Nuclear Innovation
North America LLC
122 West Way, Suite 405
Lake Jackson, Texas 77566

June 25, 2014
U7-C-NINA-NRC-140017

South Texas Project
Units 3 and 4
Docket No. 52-012 and 52-013
Response to Request for Additional Information

RAI 08.02-25 and 08.02-26

Figure 1

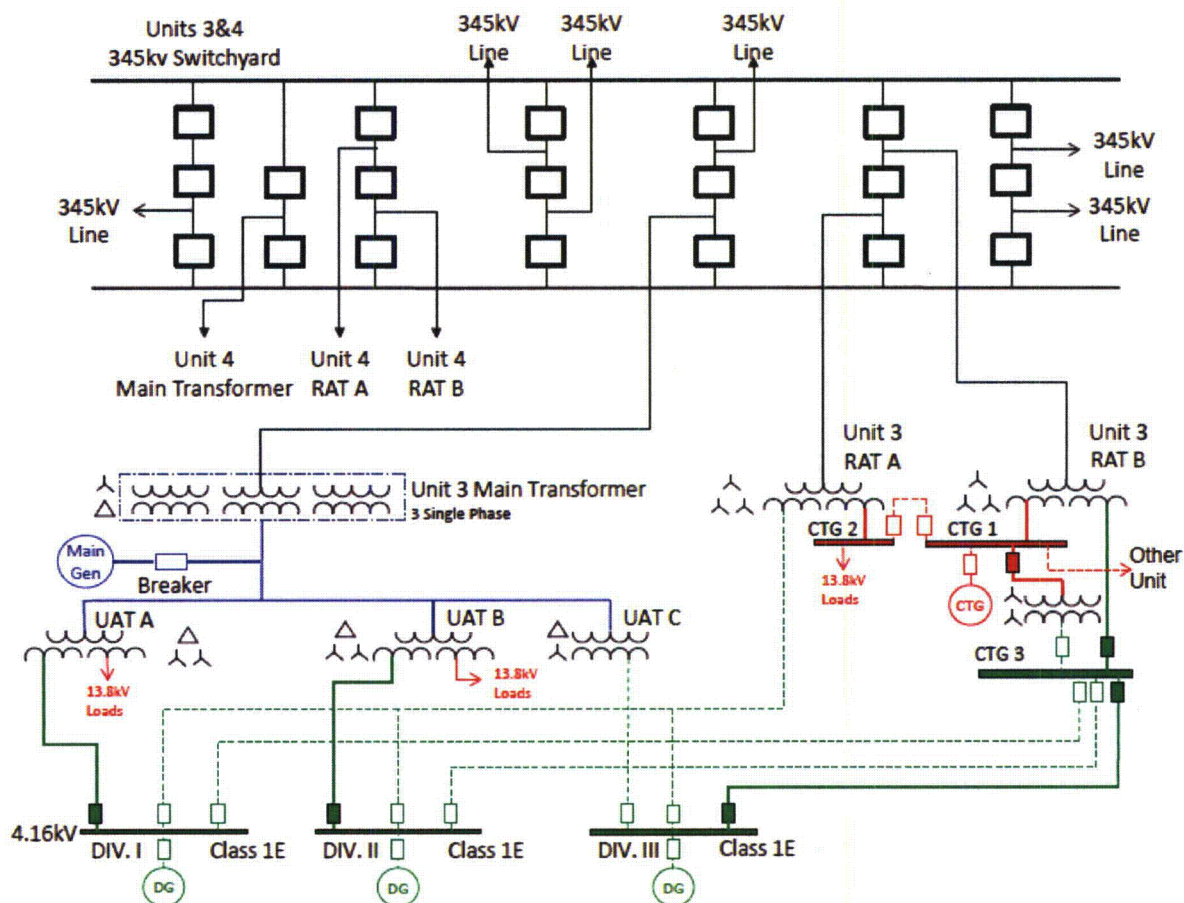
- ***If the important to safety buses are not powered by offsite power sources during at power condition, explain how the surveillance tests are performed to verify that a single-phase open circuit condition or high impedance ground fault condition on an off-site power circuit is detected.***

The Class 1E 4.16 kV safety busses at STP 3&4 are normally powered by offsite power sources during at power conditions. As shown in Figure 1, two of the Class 1E 4.16 kV busses are supplied with power from the main generator through the unit auxiliary transformers. The third Class 1E 4.16 kV bus is supplied from RAT-B. RAT-A is normally unloaded and in a standby mode. Open phase detection and alarm is provided for all three transformers (MPT, RAT-A, RAT-B) that are connected to the offsite grid.
